ADDENDUM No. 3

ADD-003

Project Title: **CSV Hamilton**
 Project No.: **22-123 (RFP #26-33)**
 Owner: **Conseil Scolaire Viamonde**
 Prime Consultant: **J.P. Thomson Architects Ltd.**

DATE: 2026-03-01
DRAWN BY: SS
SCALE: AS SHOWN
PROJECT NO: 22-123
DRAWING NO: A-101

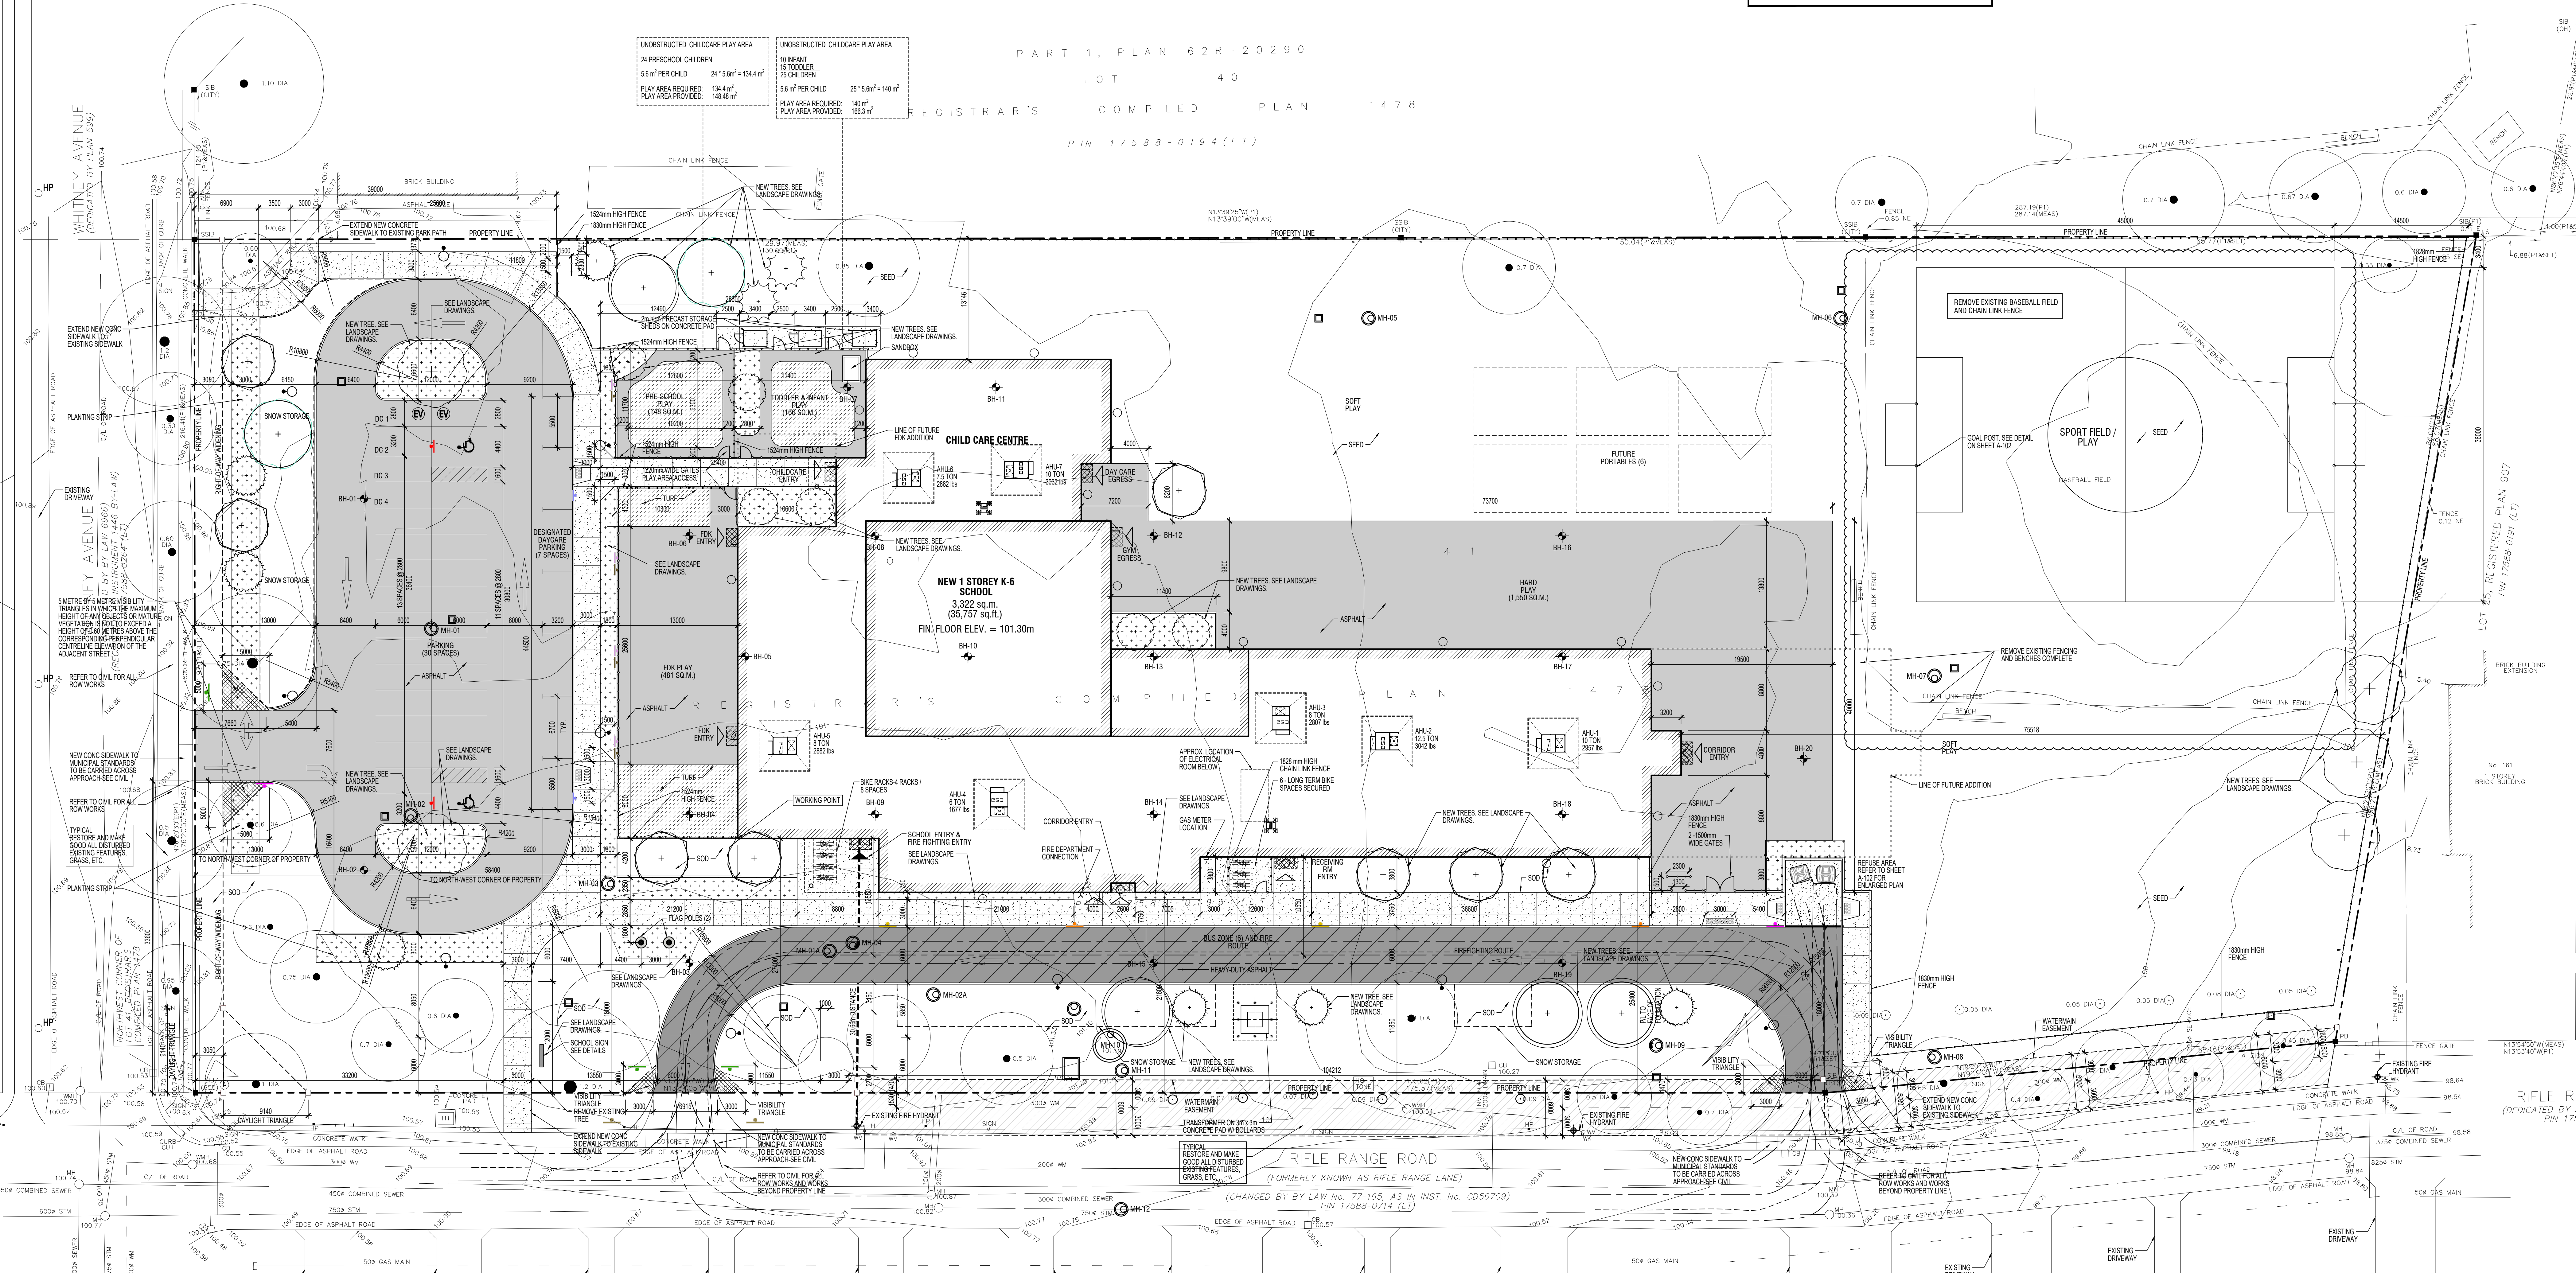
Item No. 1.3	Demolition of Existing Baseball Diamond and Fencing Refer to Site plan Drawing A-101
Item No. 1.4	Refer to Mandatory Pre-Bid Meeting Sign in sheet

Landscape drawing L-1 shows Sod over 150mm everywhere including the sport field and South and East side of the property; However, architectural site plan A-101 shows seeding on the East and South side of the property including the sport field. please advise which one to follow.

Site softscape is governed by the Landscape drawings (L-series). Refer to the Landscape drawings for the sod vs. seed limits at the sports field and the south/east areas.
